Highway Development Control Consultation Response

Planning Application Ref: PL/2026/00347

Site Address: Land at Stones Farm, West Mill Lane, Cricklade

Proposal: Approval of Reserved Matters (Appearance, Landscaping, Layout and Scale) Following Outline Planning Permission PL/2022/02452 for 140 Dwellings, a Habitat Support Area and Associated Landscaping and Works

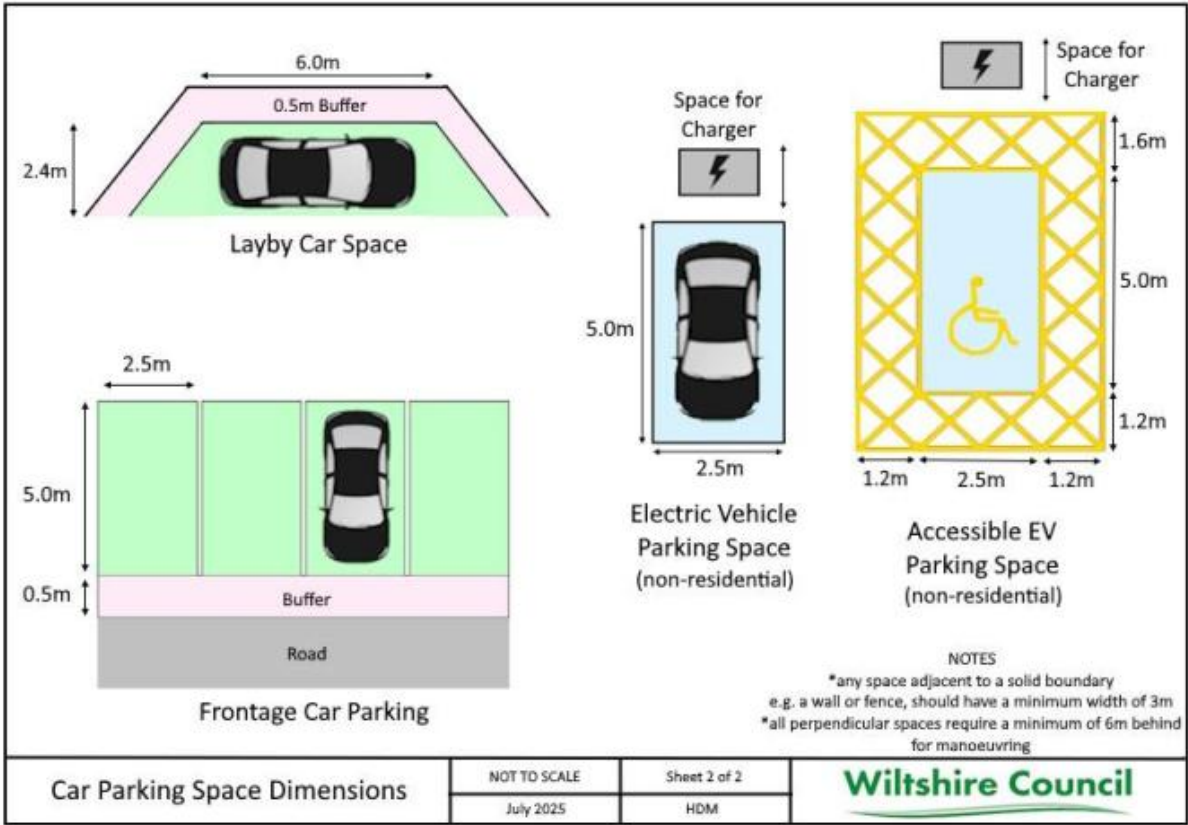
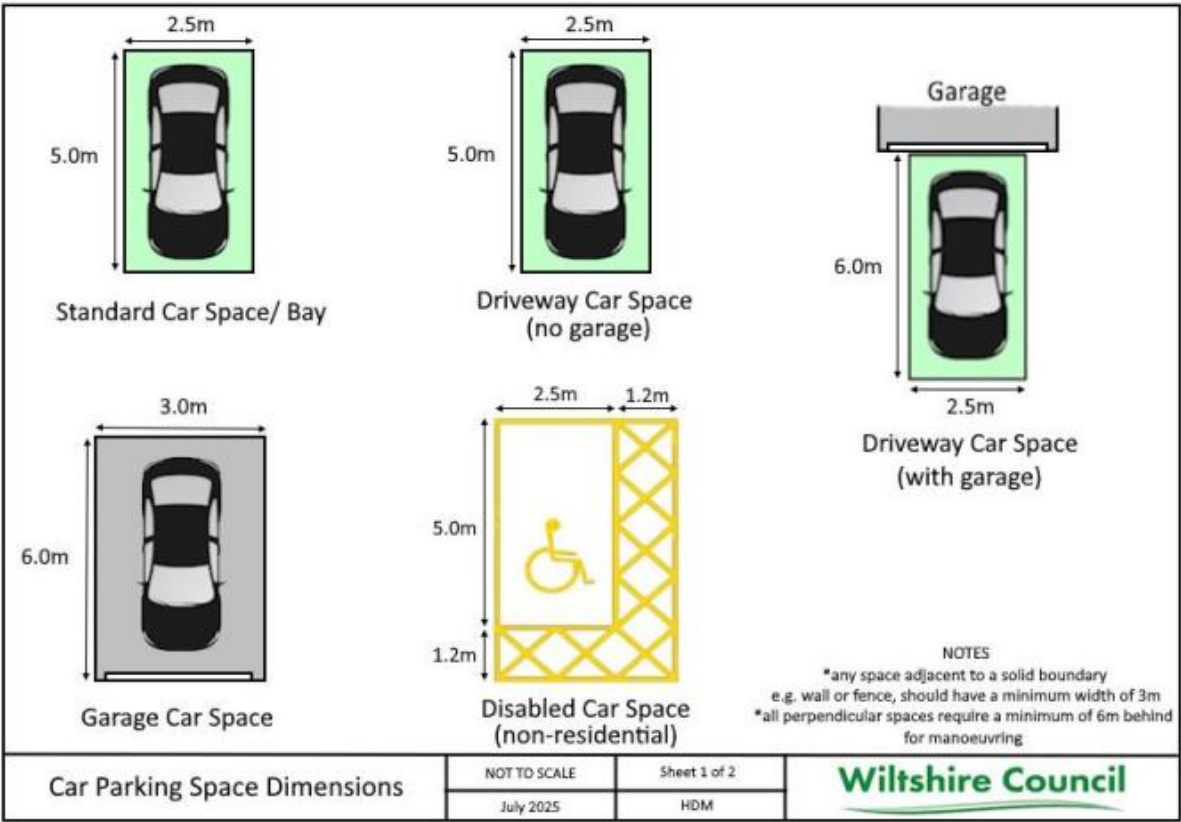
All visibility splays should conform with standard for a design speed of 20-mph and should provide splays measuring 2.4m by 25 m to the nearside carriageway edge. This should be achieved by all side roads and private drives. Regarding specific details in the plans:

- the visibility splay from the junction of the private road falls across the allocated parking for Plot 138.
- Visibility splay to the right of private road across parking for Plot 120.
- Tree to right of shared drive of Plots 106 & 107 within visibility splay.
- Visibility to be shown as achievable from private shared drive 106/107.
- Visibility splay from side road between Plots 41-51 across the frontage of Plot 51 and should be demonstrated that it can achieve 2.4 m by 25 m clear of obstruction.
- Splays from Plots 14 & 15 across frontages and to be demonstrated or secured.
- Splays to 2.4m by 25m at side road and Plot 92
- Splays across frontages of Plots 57 & 58
- Visibility splays across Plots 54, 55 and 56 and from the junction across Plot 56 required to demonstrate 2.4 m by 25 m.
- Visibility from private drive at Plot 70
